# **Lindum Vale Precinct Structure Plan Amendment C205 to the Hume Planning Scheme**

## **Expert Witness Report**

12 February 2018

**Stormy Water Solutions**

**Figure 1 Possible Alternative Drainage Strategy (2018)**

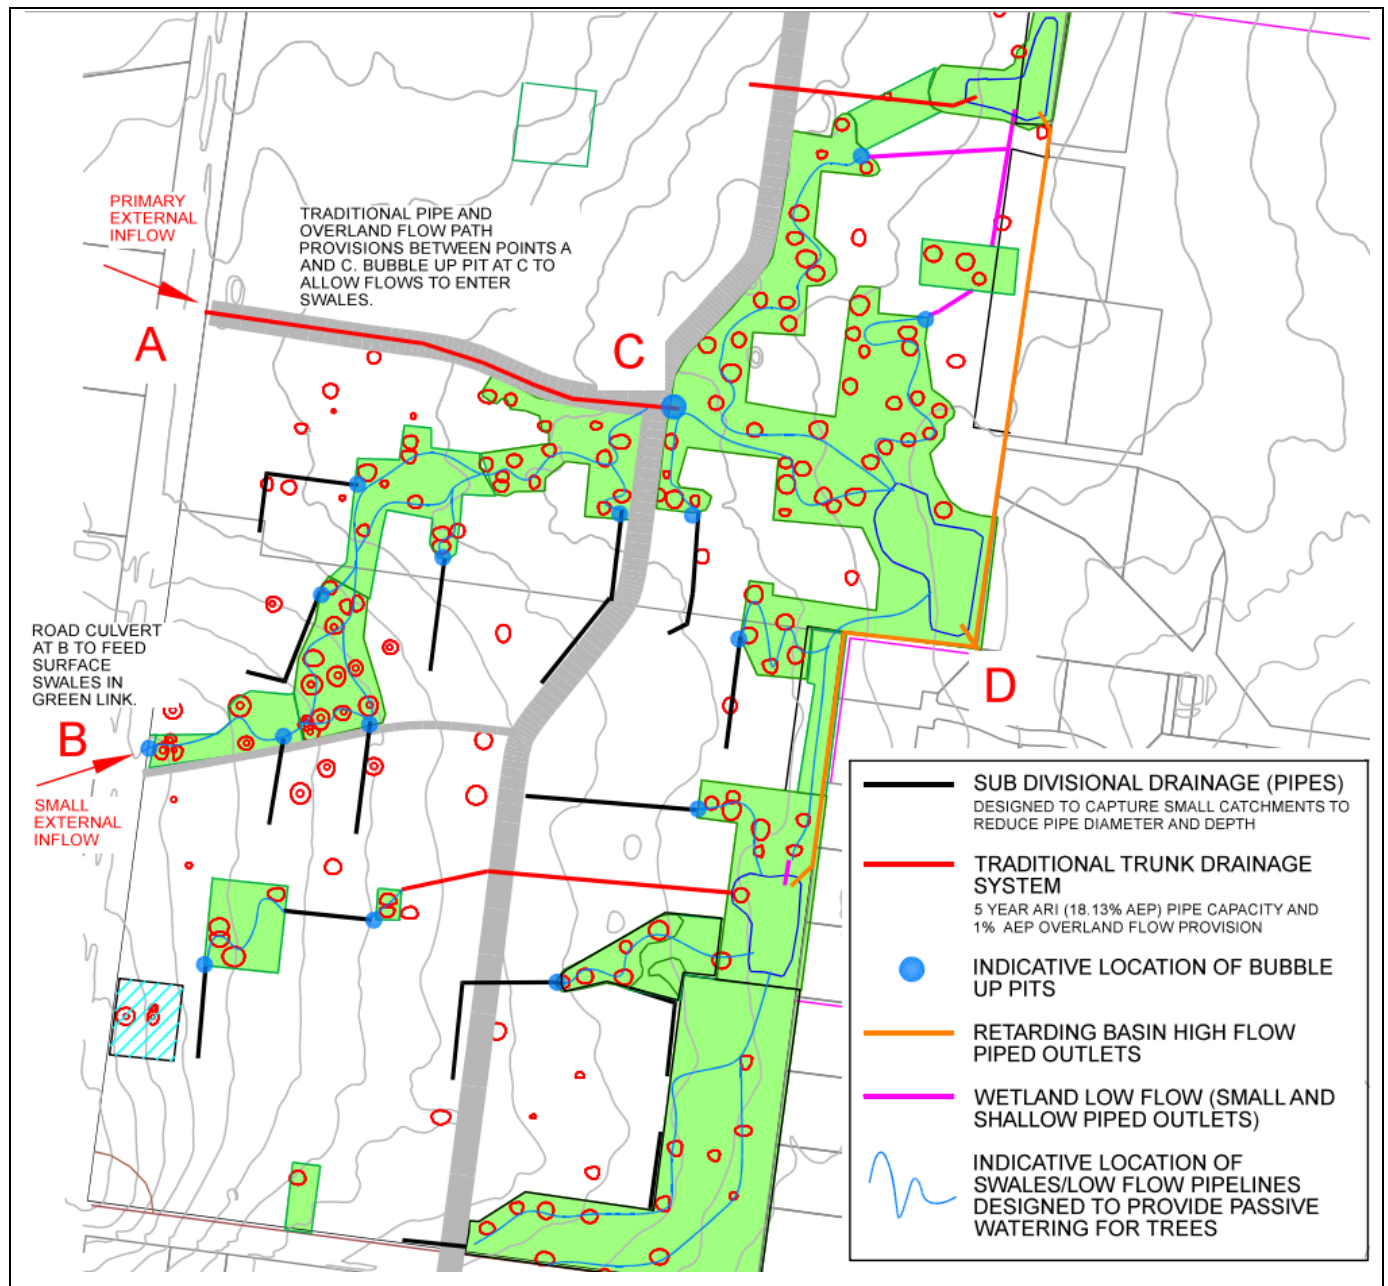
However, the strategy does not appear to define the road culvert connection required at Point B, Figure 1.

Figure 1 indicates that, provided due consideration is given to the drainage design as detailed above, Amendment C205, Plan 3, Future Urban Structure (16/1/18) allows enough reserve space to allow this alternative drainage strategy to be adopted.

As detailed in Figure 1, I consider that with due drainage design considerations, almost all the trees restrained in reserves could be passively watered via a bubble up arrangement at outfall points to the green link areas.

If the alternative strategy as per Figure 1 (or similar) were adopted, then the only design considerations going forward would be individual assessment of each tree (or group of trees) and appropriate throttling of bubble up pit mechanisms etc., to ensure optimal watering.
